A-7010 GSL A-7030 GSL STEREO TAPE DECK SERVICE MANUAL

TEAC MANUAL CHANGE SHEET

P.S. AMPL. CIRCUIT CHANGE

P.S. AMPLIFIER

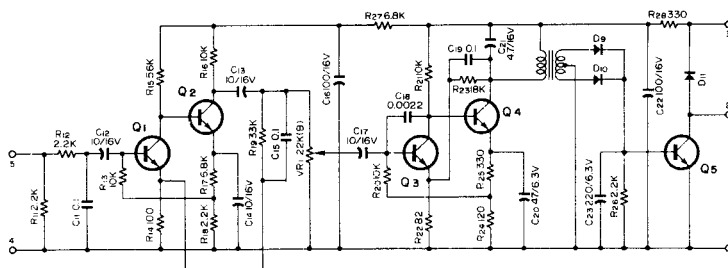
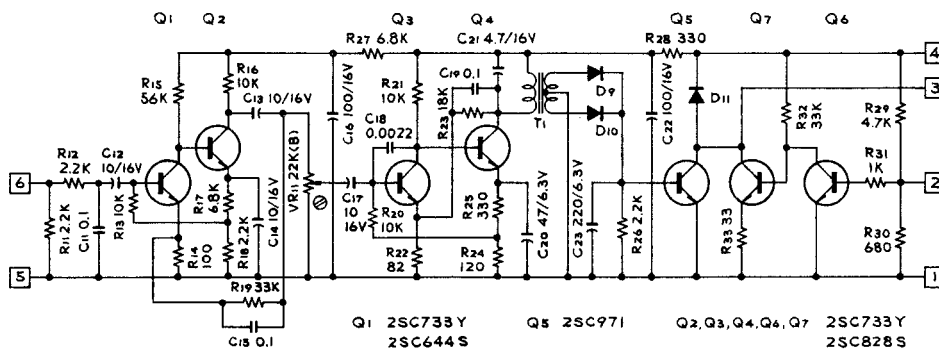
The sensing post of the automatic reverse circuit has been the source of noise when using back-coated tapes, such as SONY SLH-BL, Scotch #206 or 207, and others. A new printed circuit board assembly is now being used to eliminate this problem. (See diagram.) If the customer desires, his older model may be modified to include this change. Order part #50491040

EXPLODED VIEW 5, BELOW THE MAIN CHASSIS

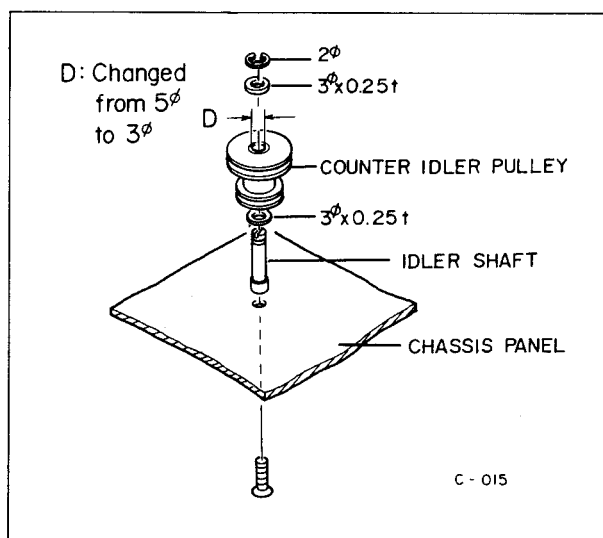
COUNTER IDLER PULLEY CHANGE

When replacing either the Idler Pulley Shaft or the Counter Idler Pulley, they must both be replaced at the same time, due to the incompatibility between the old and new diameters. This applies especially to the older models (before this change was incorporated) and it is also a good practice to replace both parts during any replacement to provide uniform wear characteristics between the parts.
